ADDENDUM 01

DATE 02.04.23
 PROJECT NO. 2154
 PROJECT WEST FIELD SR. SEMINARY
 FROM STUDIO 333 ARCHITECTS

This Addendum forms a part of the Contract Documents and modifies the original Bidding Documents dated 01.25.23, as noted below. Acknowledge receipt of this Addendum in the space provided on the Bid Form. Failure to do so may subject the Bidder to disqualification.
This Addendum consists of 2 pages and the attached Drawing Sheets SD1.1, CE1.1, CE2.1, CE3.1, CE4.1, CE5.2, L201, A1.3, A5.1, A5.11, EP101, EP102, EE501, ES101,

CE1.1

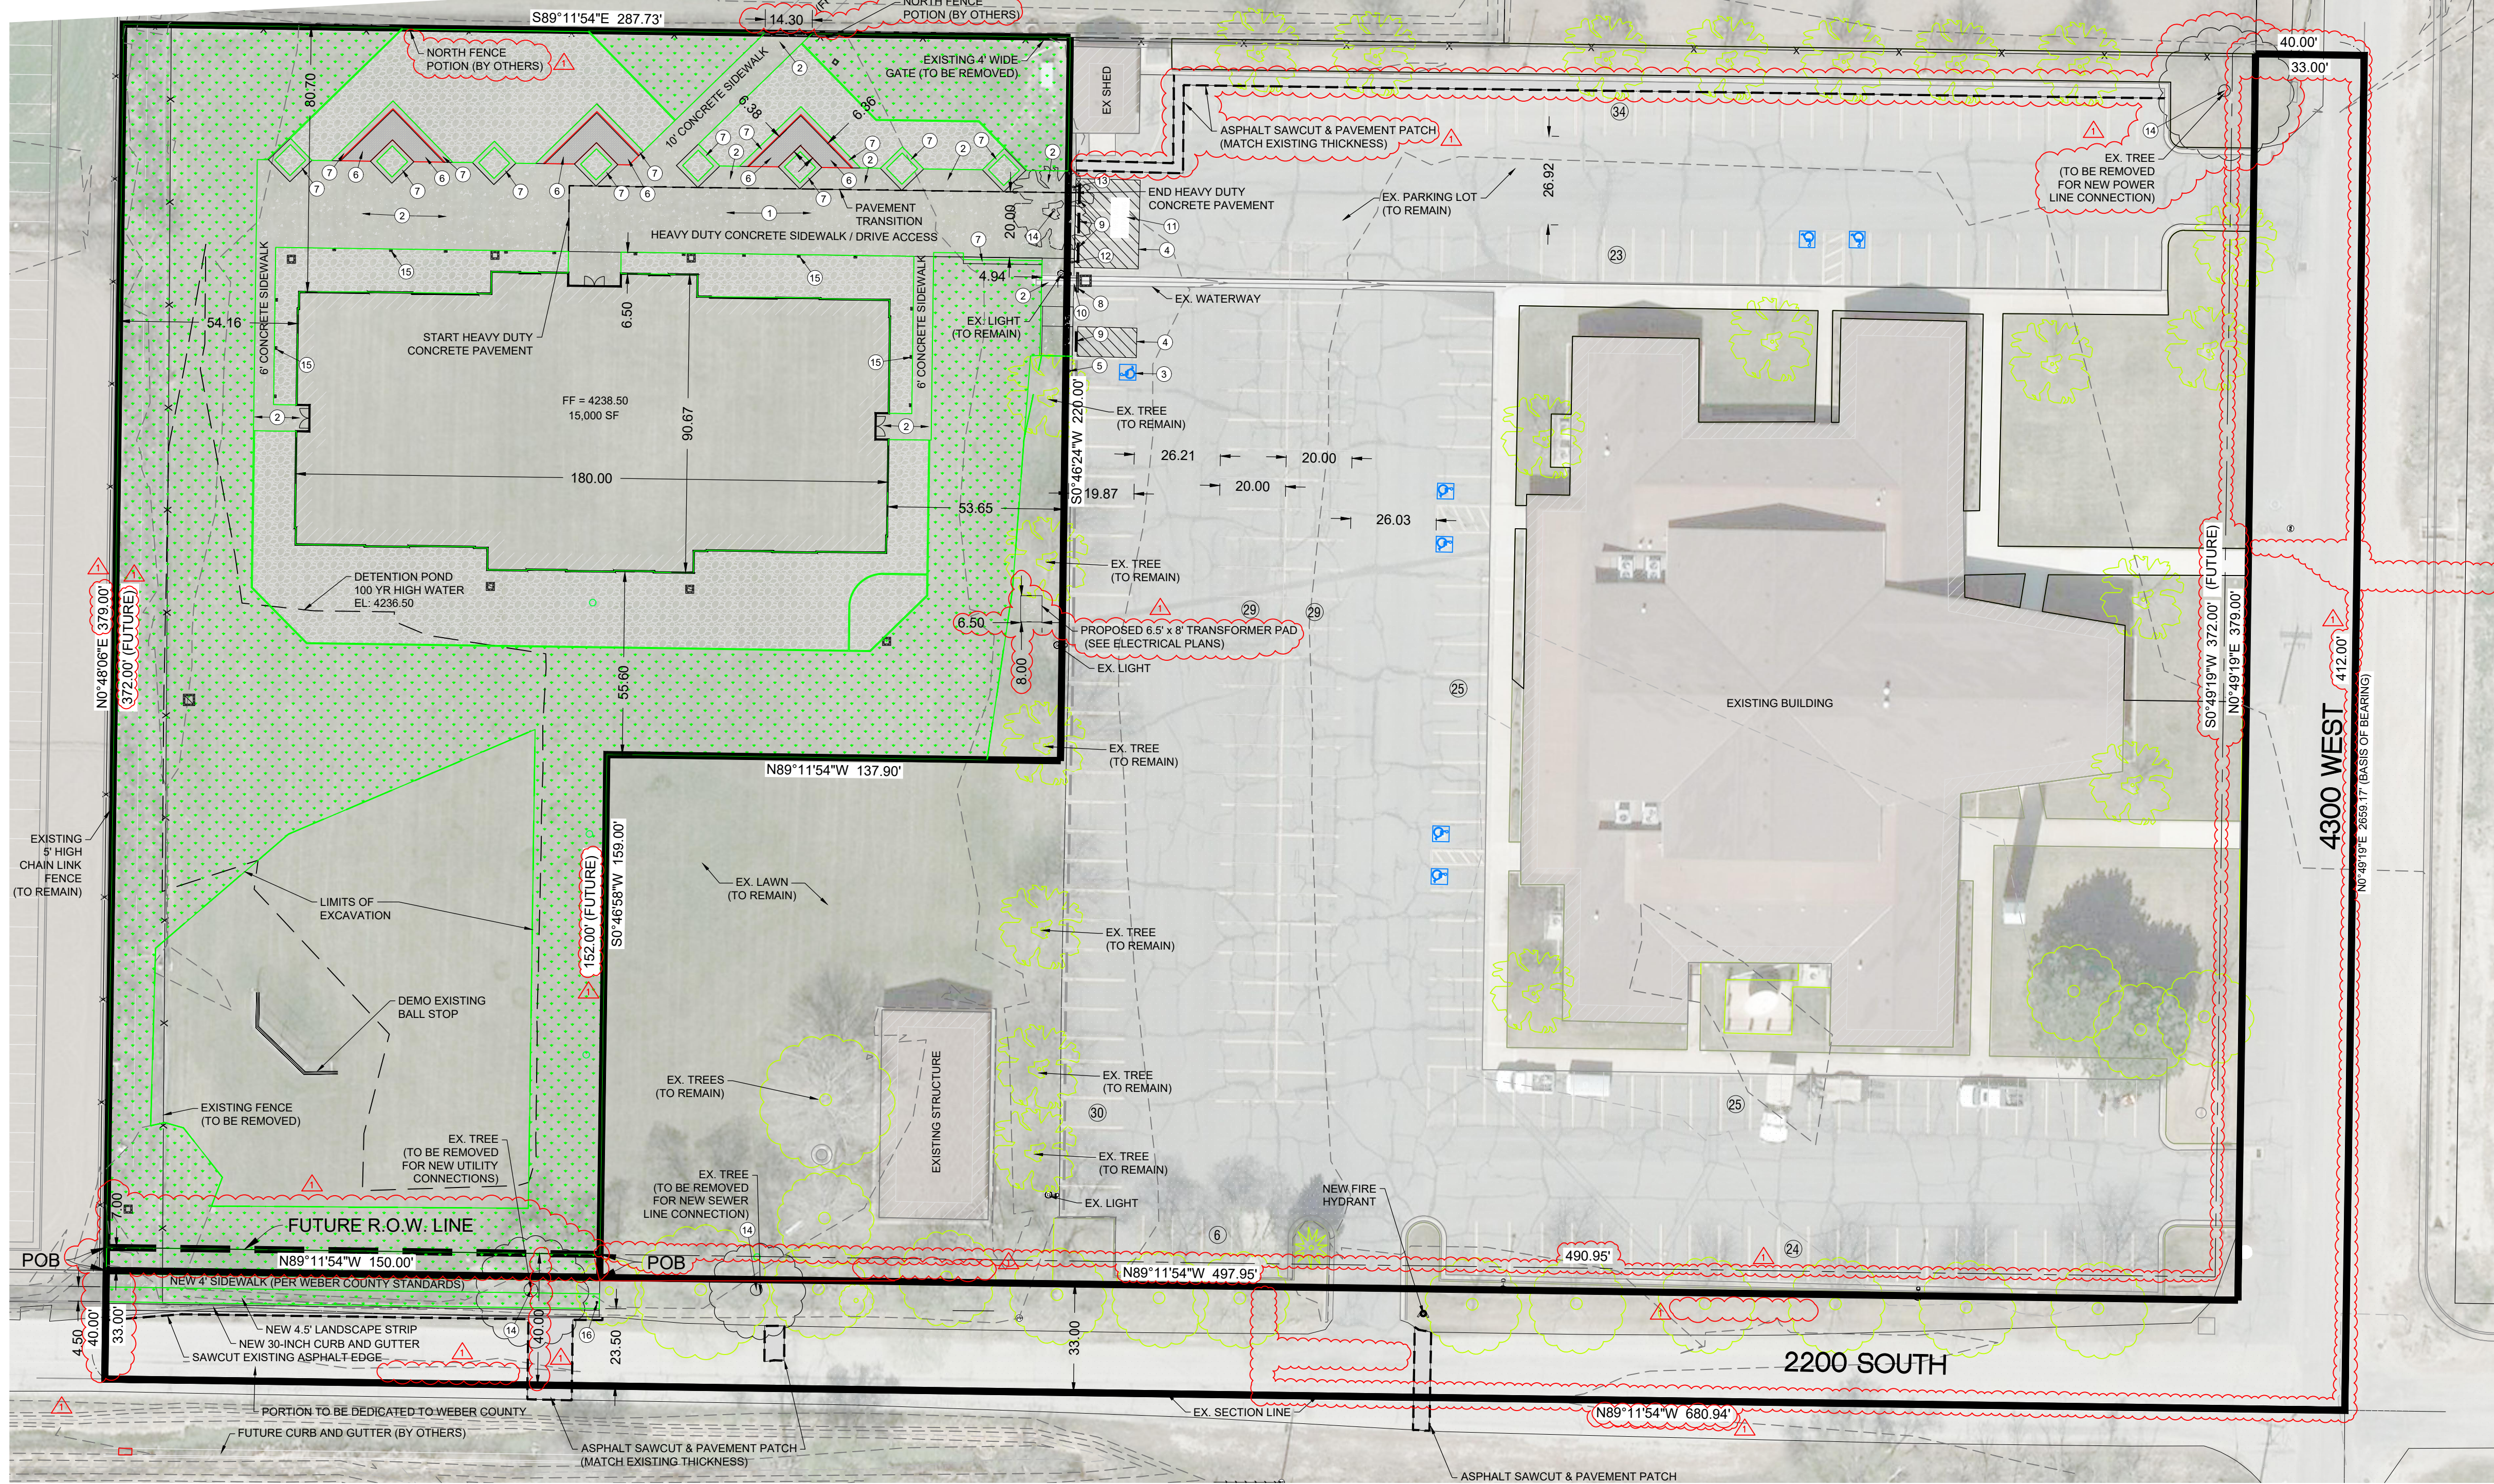
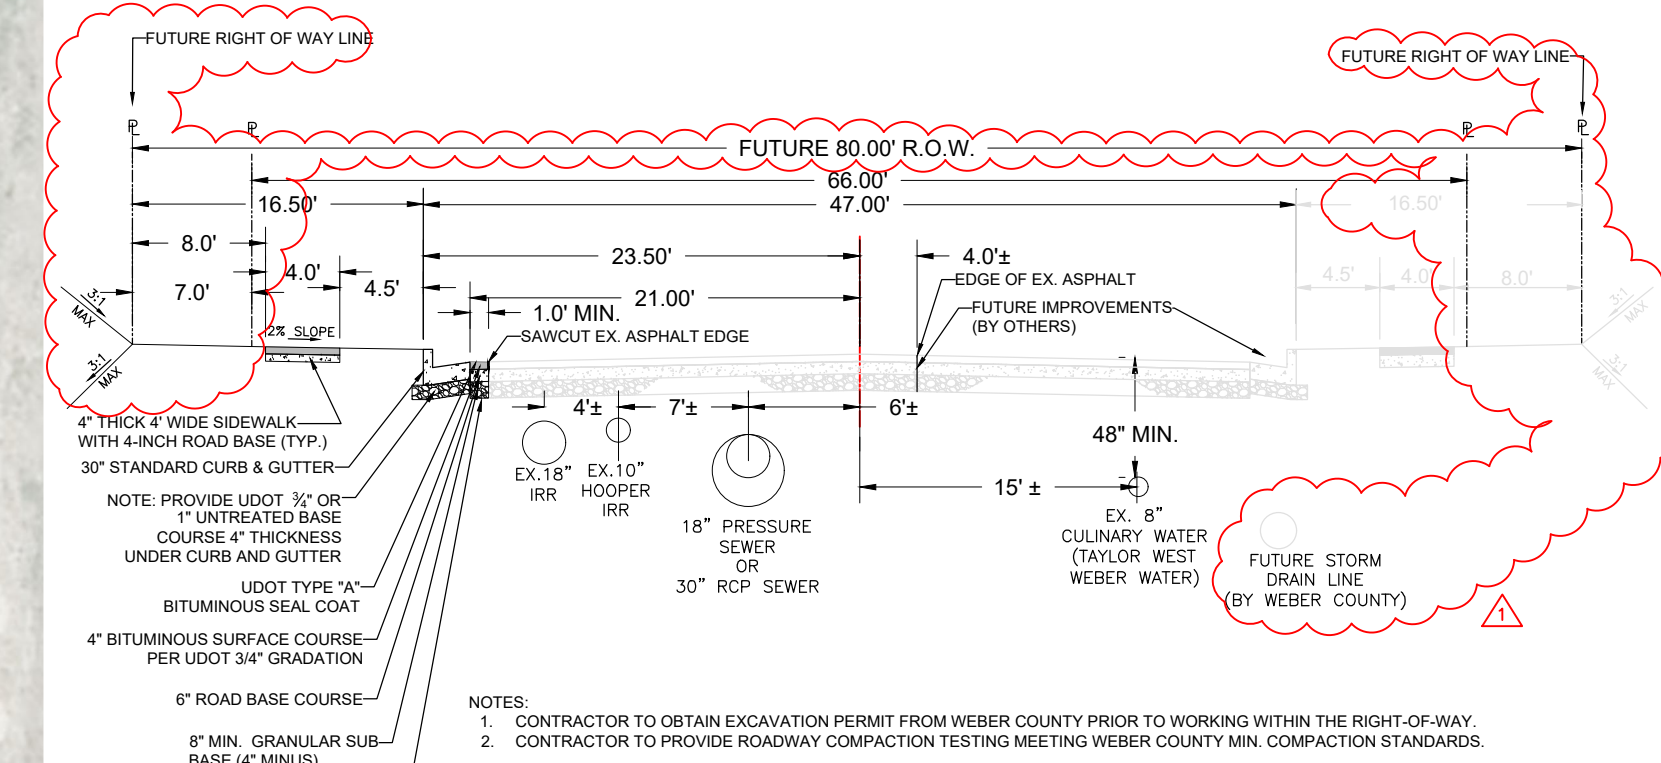
- 2. Sheet CE1.1 - SITE PLAN:
 - a. Revised boundary call outs and boundary shown on 2200 South and 4300 West to reflect the required 80’ right of way dimension that Weber County is requiring for this project. The existing 33’ half width for the right-of-way is also shown. Future dimensions measured from the future 80’ right of way were also dimensioned.

- b. Revised the northern fence callouts to show fencing (to be installed by others), and dimensioned the minimum fence break width for the sidewalk connection.

- c. Revised the section view on the right hand side to show the extended 7’ of additional width (for 8’ total behind the sidewalk), that transitions down to a 3:1 slope from the adjusted future property line at the 80’ right of way line. The future Weber County storm drain pipe was also added to the road section view.

- d. The limits of excavation line (just north of the added label “Future R.O.W. Line”, was also adjusted to extend 7’ further to the north to account for the additional slope grading required.

- e. Added location of transformer pad location with reference to see electrical plans.
 - f. Added removal of Existing Tree by north church house entrance (for electrical conduit routing).

- g. Added sawcut and 3’ asphalt width removal by north curb line of church (for electrical conduit routing).
 - 3. Sheet CE2.1 - GRADING PLAN:
 - a. Revised the grading where the 80’ right of way extends to and the associated 7’ of additional slope grading that was added along the south side of the detention pond.

CE2.1

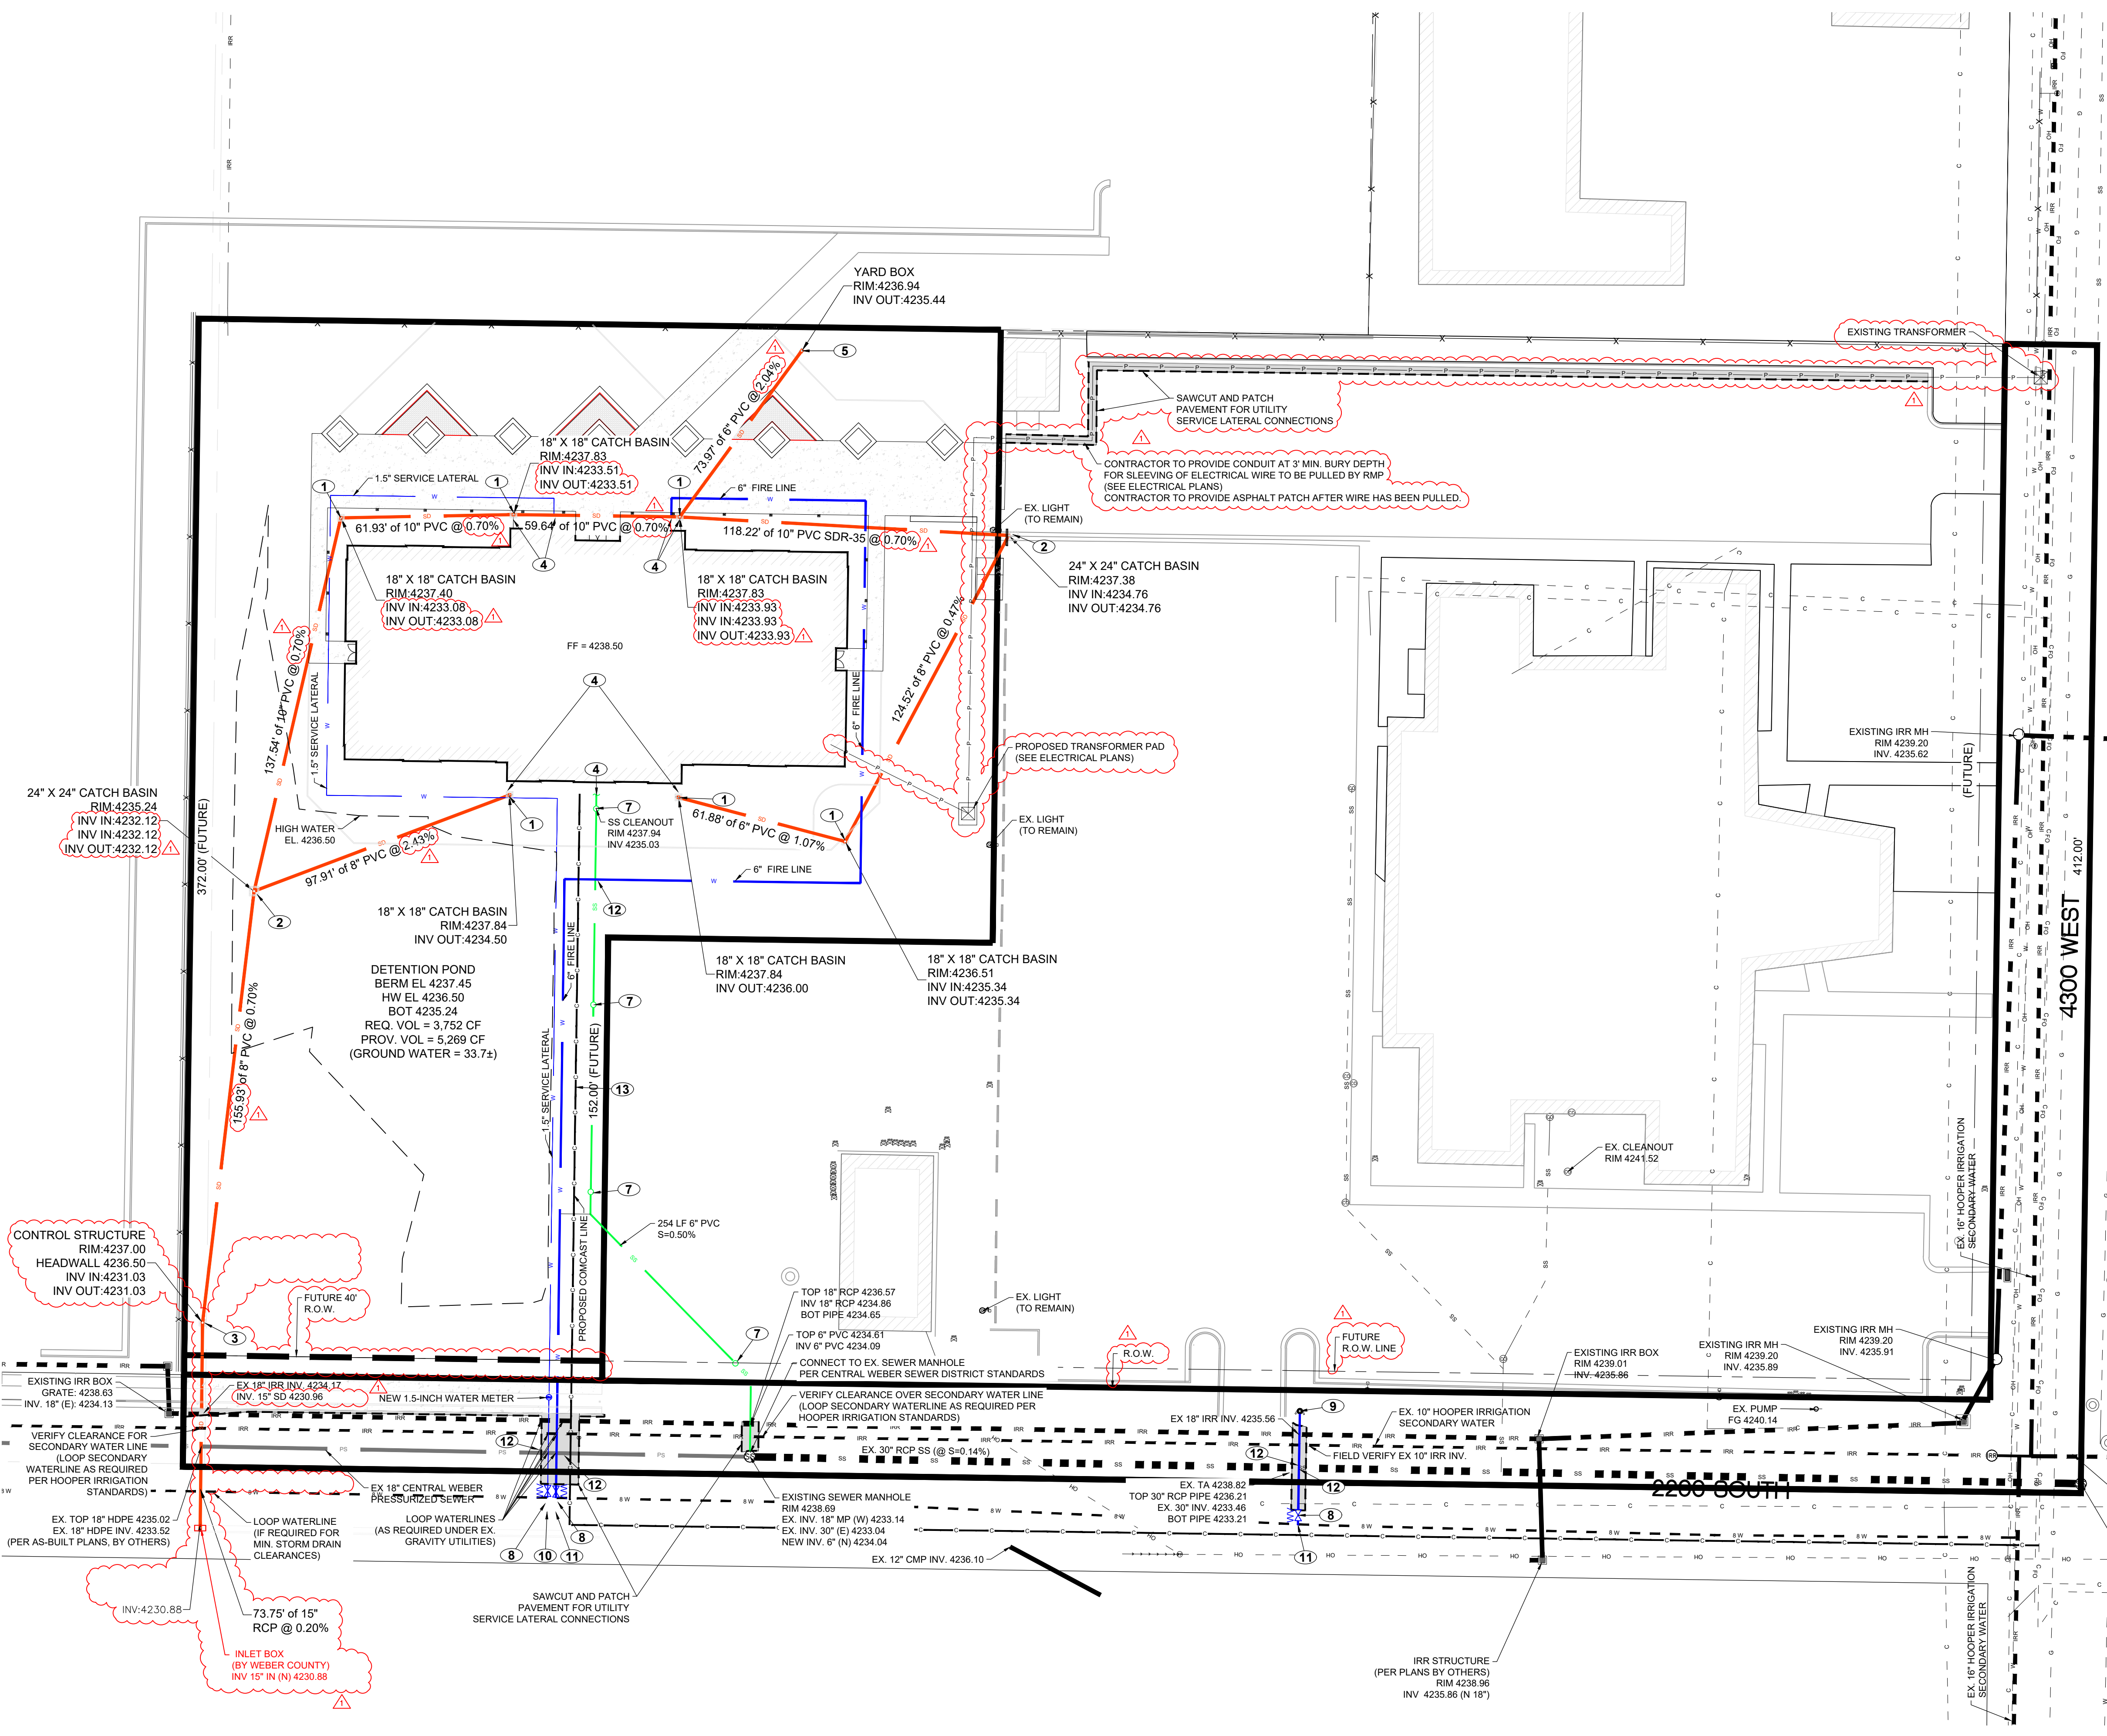
- b. Labeled the existing right of way line and the future right of way line.
- c. Added location of transformer pad location with reference to see electrical plans.

3 OUTLET CONTROL STRUCTURE
Scale: NTS

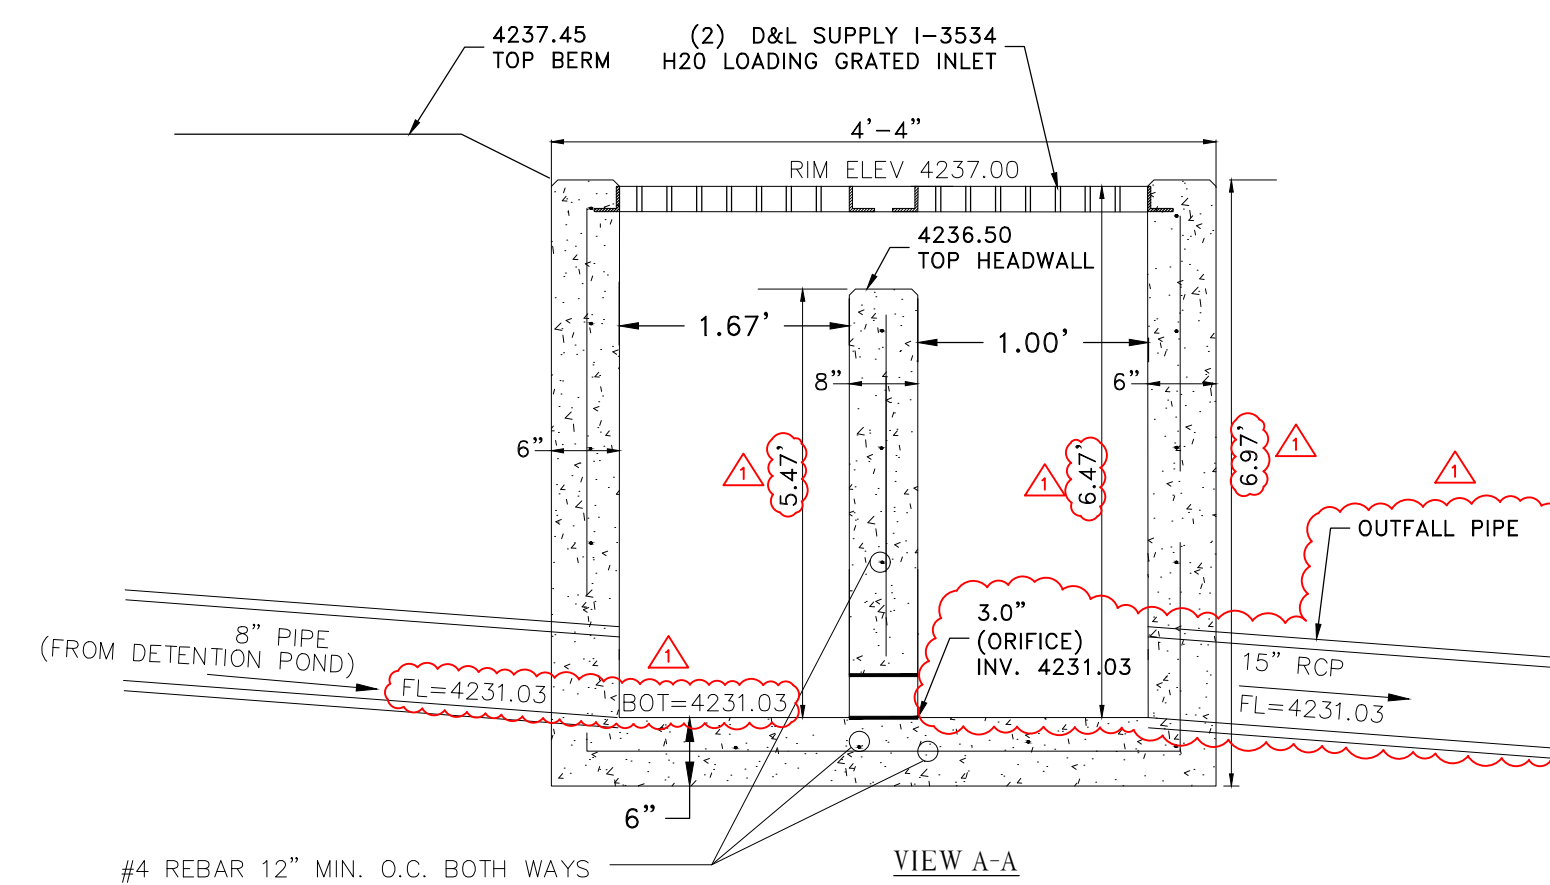
- c. The 7' additional disturbance area was also clouded where limits of disturbance was adjusted.
- 6. Sheet CE5.2 - CIVIL DETAILS:
 - a. Detail 3 for the outlet control structure was adjusted to reflect the allowed lower invert connection to the future storm drain inlet box to be provided by Weber County. The dual 8" PVC pipe for the outlet pipe were replaced with a single 15" RCP outlet pipe. The bottom of box elevation was added, and the respective increase to the headwall and overall box dimension was updated for the required increased box depth.
